**MANCHESTER-BOSTON REGIONAL AIRPORT
GREEN DRIVE CARGO FACILITY APRON AND ACCESS ROAD**

ADDENDUM NO. 1

DATE: March 17, 2022
TO: ALL BIDDERS
FROM: McFarland-Johnson, Inc.
53 Regional Drive
Concord, NH 03301
PROJECT: Manchester-Boston Regional Airport
Manchester, New Hampshire
Green Drive Cargo Facility Apron and Access Road

WATER SERVICE CONNECTION DETAIL

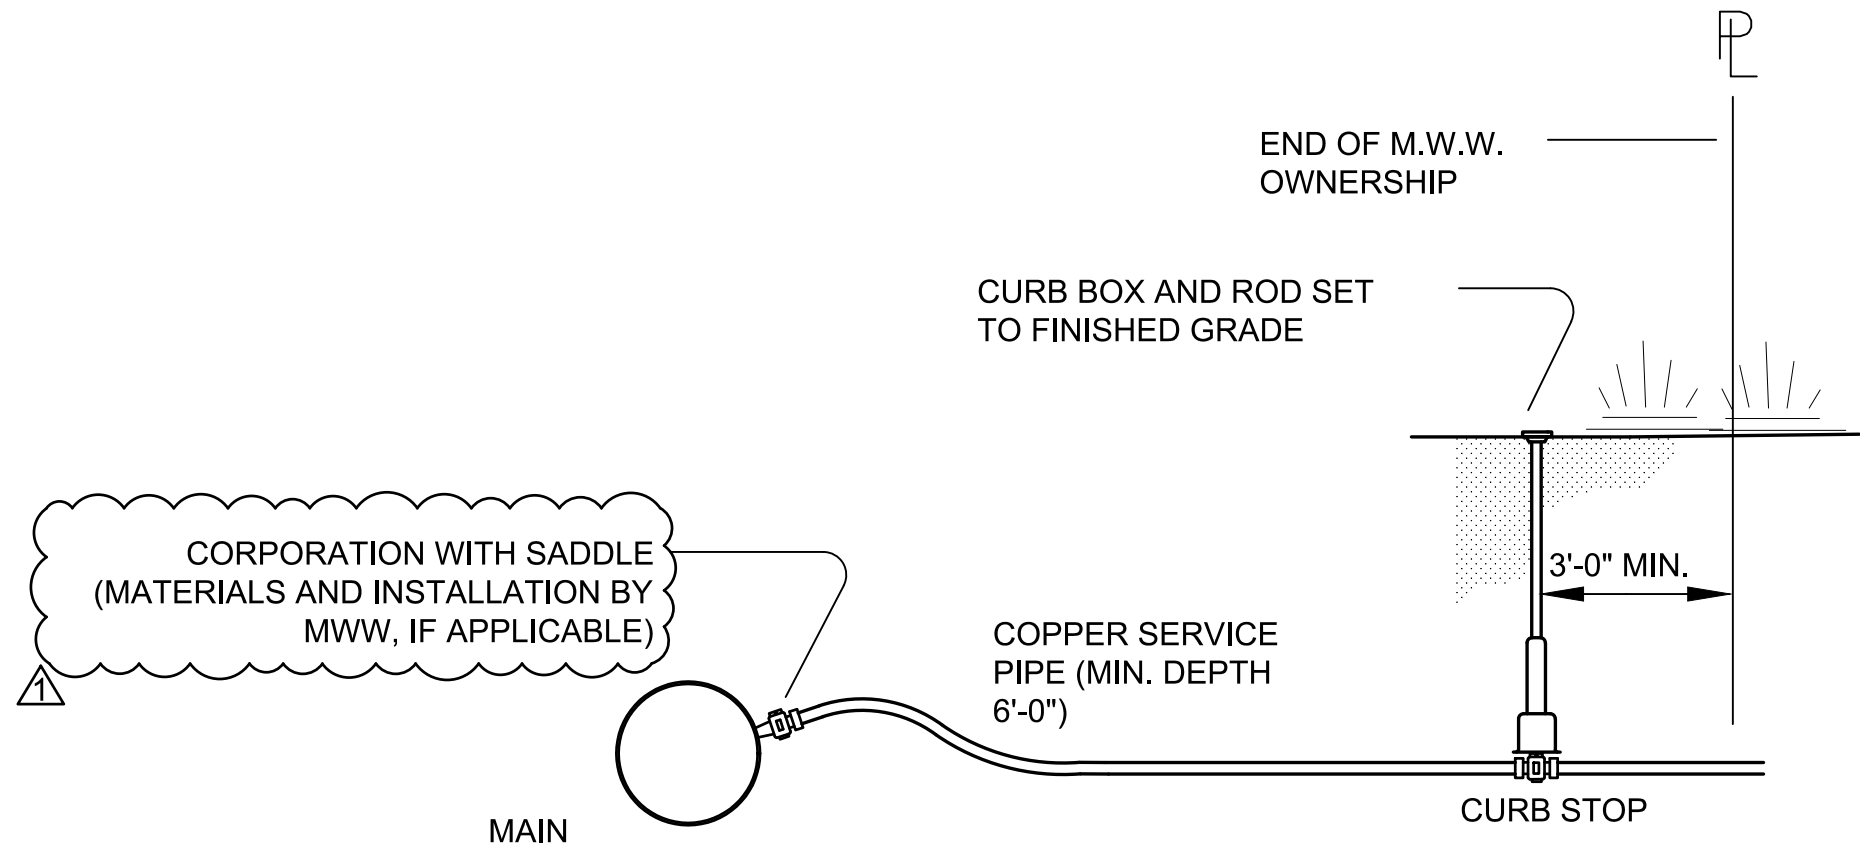
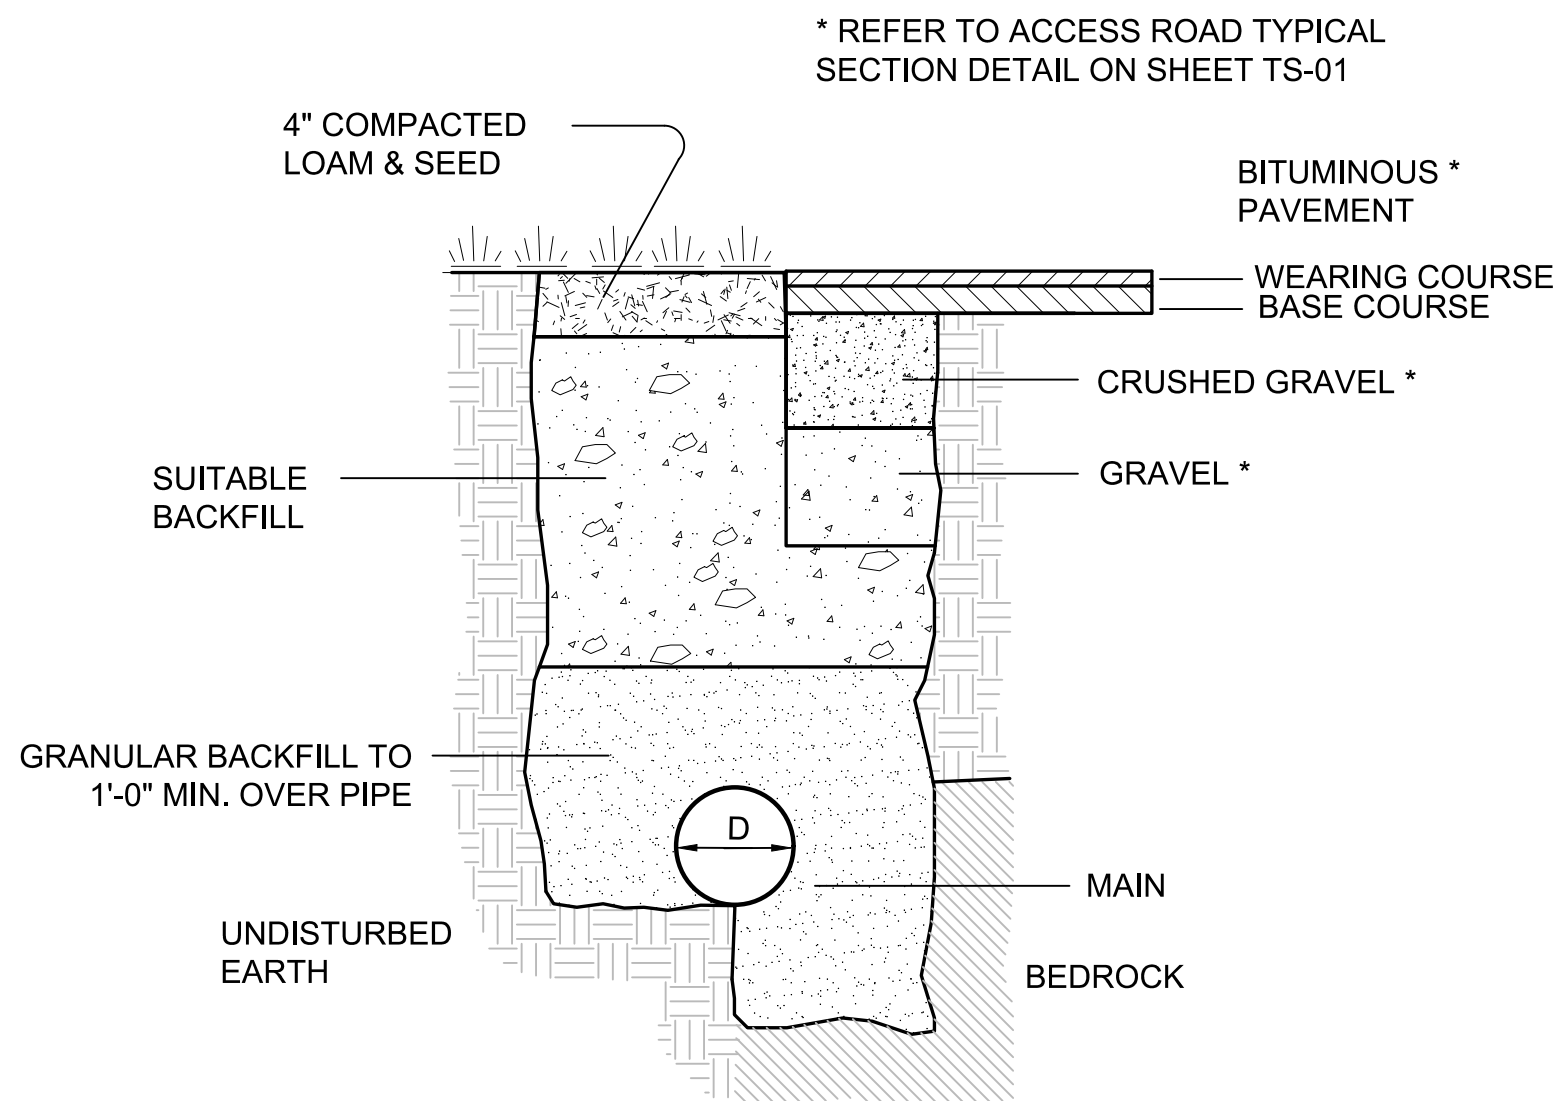
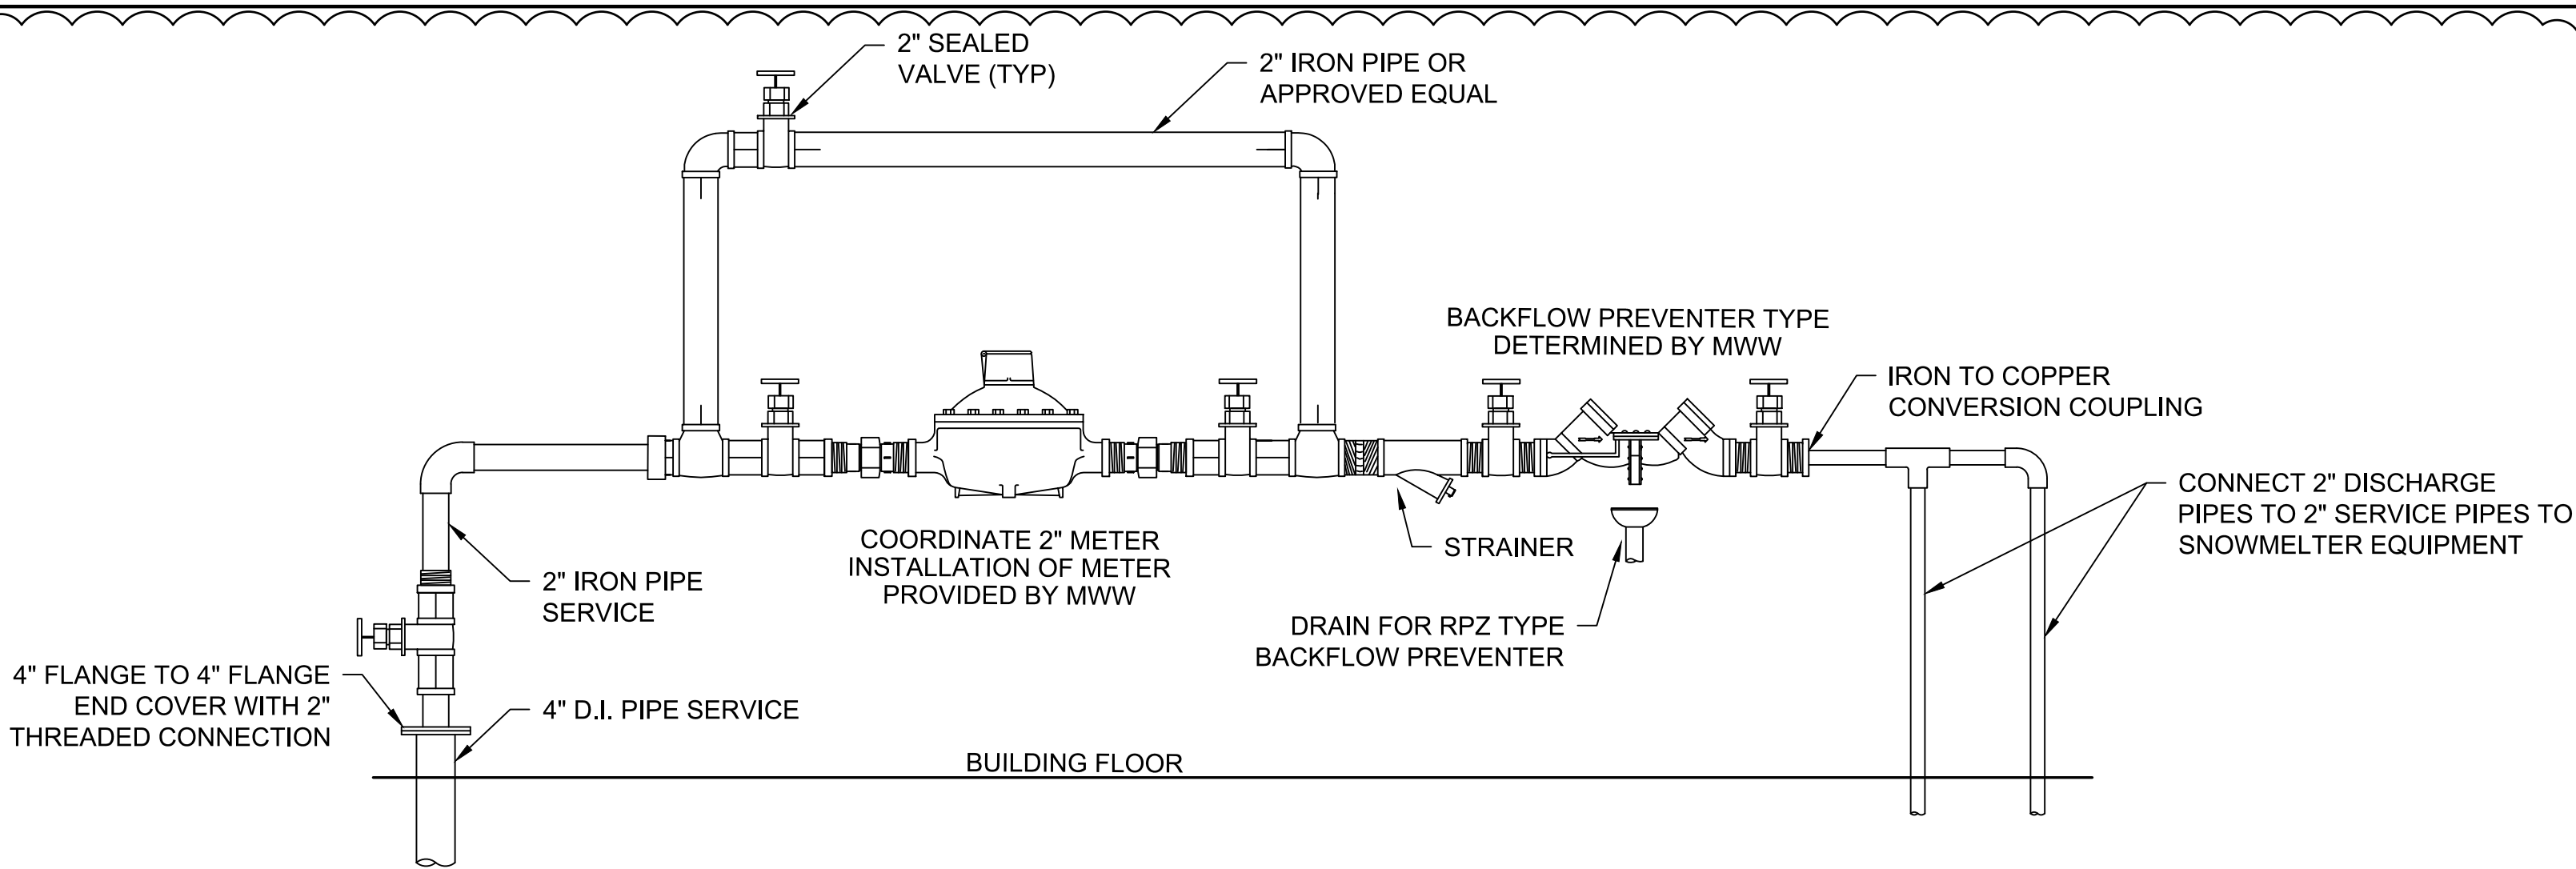
Section 300-2.8 Water Line and Fitting Materials, 3): **Replace 3) Material:** Remove Polyethylene Service Tubing and Replace with Copper Service Tubing

Section 300-2.8 Water Line and Fitting Materials: **Add 4) Material:** Add Polyethylene Wrap for Ductile Iron Pipe

Section 300-2.8 Water Line and Fitting Materials: **Add 14) Material:** Add Copper Meter Setters and Check Valves (No Lead Brass)
